ADDENDUM NO. 2

TO: PLANS AND SPECIFICATIONS FOR STATE OF MISSOURI

**Improve Flight Line and Building Renovation
Limited Army Aviation Support Facility
Jefferson City, Missouri
PROJECT NO.: T2037-01**

1 MAIN FLOOR POWER PLAN - ADDENDUM 2
3/32" = 1'-0"

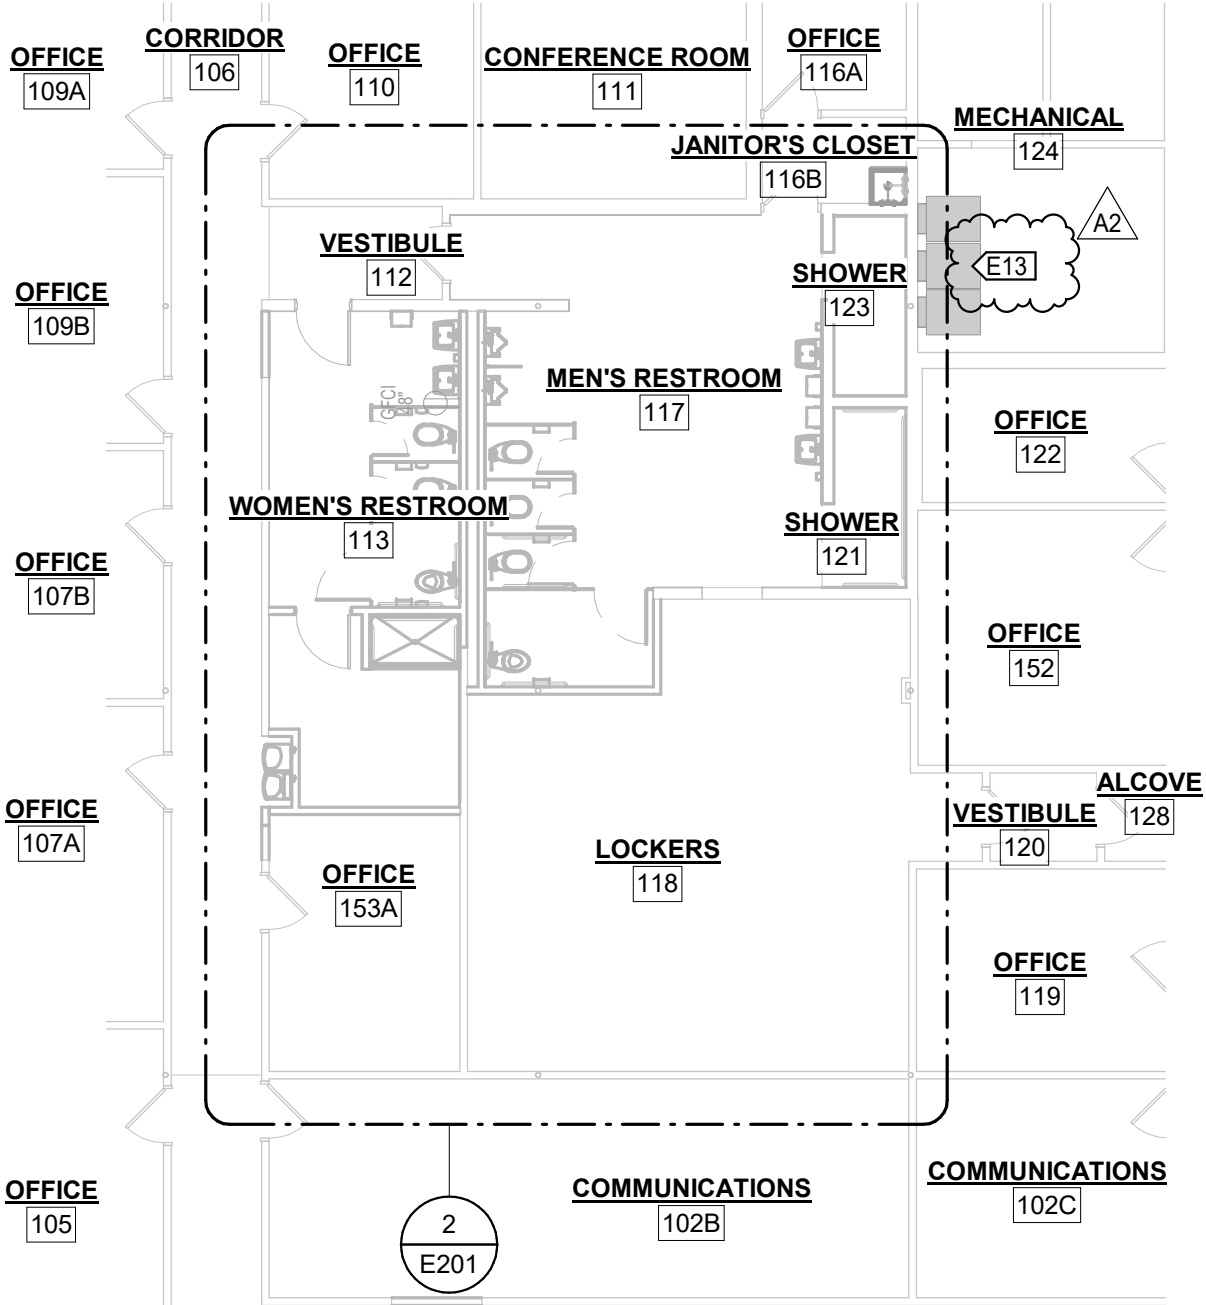
4. SHEET E101

- a. ADD Keynote E13 per attached Exhibit A2-E101.

VALUE	DESCRIPTION
E13	PROVIDE NEW DEDICATED CIRCUITS TO THE BREAK ROOM AND OFFICE MINI-SPLIT SYSTEM (FCU-1 & HP-1) FROM EXISTING 120/208V PANEL IN THIS LOCATION.
